City of San Antonio, Texas

RE: MDP 011-06 Two Creeks North

Re: Two Creeks North Master Development Plan, MDP # 011-06

**TWO CREEKS NORTH SUBDIVISION
MASTER DEVELOPMENT PLAN**

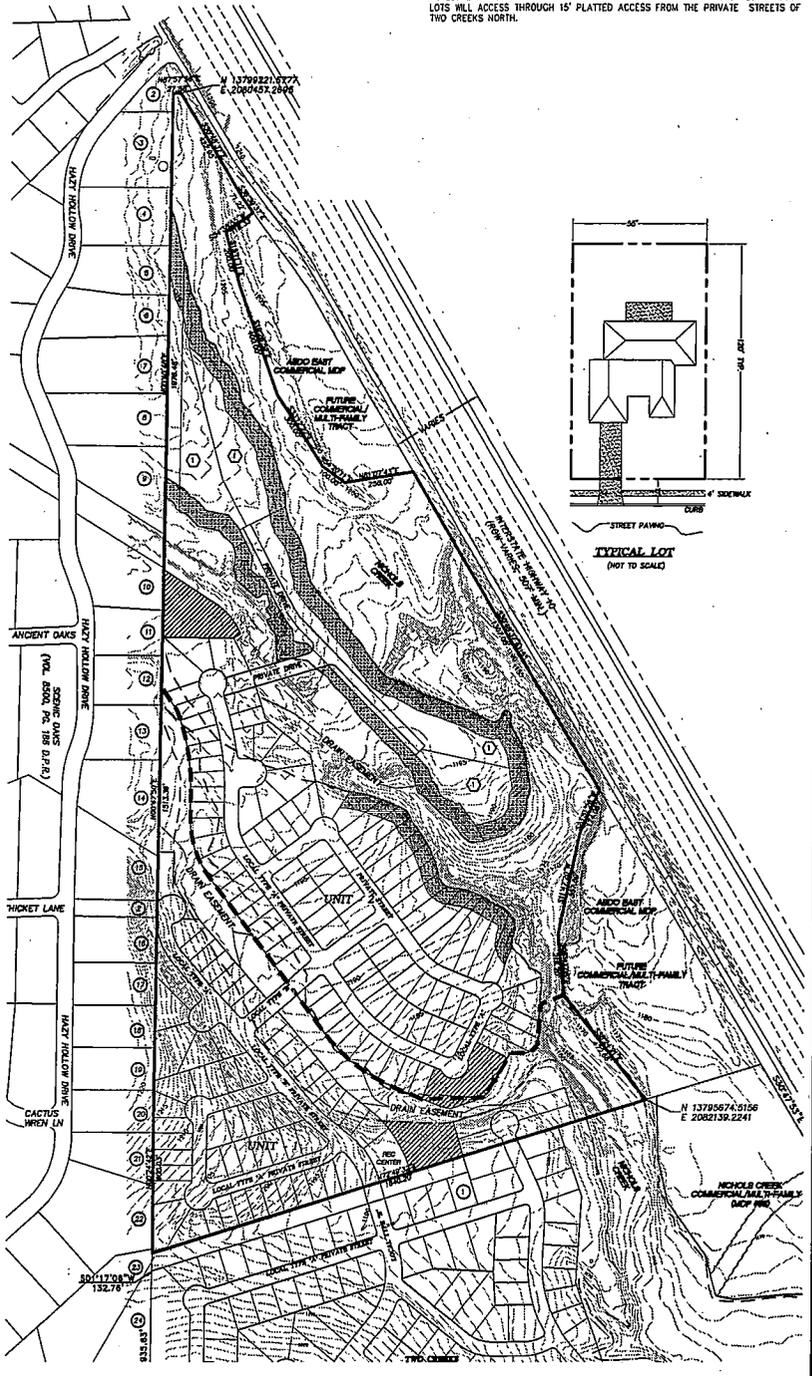
In consideration of public safety and convenience, excessive grades by reason of topography should be avoided in street layouts and arrangements.

DSD – Traffic Impact Analysis & Streets indicates the following requirements and onsite improvements are necessary and shall be provided by the developer, on and before the completion of the Two Creeks North, at no cost to the City of San Antonio:

- All roadways shall follow Table 506-7, Functional Classification System Description and shall comply with UDC 35-502(a)(9).
- All access roadways shall provide clear sight distance on all existing and proposed roadways in order to provide adequate obstruction free viewing distances for approaching traffic. All signage, landscaping, and improvements shall be selected and located so as to not block these clear sight distance areas.
- Sidewalks along all interior and exterior roadways are to be installed in accordance with UDC 35-506(q).

SAWS Aquifer Protection and Evaluation will require the following pursuant to the Aquifer Protection Ordinance No. 81491, for Plat Certification.

- 100 year Flood Plain Shown and Buffing (if applicable)
- Sensitive Recharge Features and Buffing (if applicable)
- Category Letter for All Site Specific Plats (if Category 2 or 3, an Aquifer Protection Plan is required)

- According to the Water Quality Ordinance # 81491, Section 34-914, buffering may be required.

Additionally, a Water Pollution Abatement Plan or Contributing Zone Plan must be submitted and approved with the Texas Commission on Environmental Quality (TCEQ) prior to construction.

Parks and Recreation recommends approval with the following conditions:

- All land provided for Parks/Open Space is dedicated to the Home Owners Association;
- A Provision and Maintenance Plan is submitted to this department at time of platting.
- All amenities provided follow design criteria and specifications of UDC section 35-503(h) in order to gain credit for improvements.
- Remove the note "Two Creeks Subdivision has an excess of 5.98 ac of Parkland". No Joint User Agreement with the school district was furnished to this department therefore no credit can be given for land at this school site location.

Tree Preservation states that this project will be subject to:

- 2003 Tree Preservation ordinance standards per UDC Section 35-523 – a Tree Preservation Plan is required prior to any work on site. This can be submitted either as a site work permit or at the platting stage. Additional permitting fees and affidavits will be needed to obtain tree permits during the platting and/or site work stages.

The property must be platted in accordance to the UDC and the Major Thoroughfare Plan to reflect the approved MDP. It is suggested to work closely with the school district, so they can plan accordingly.
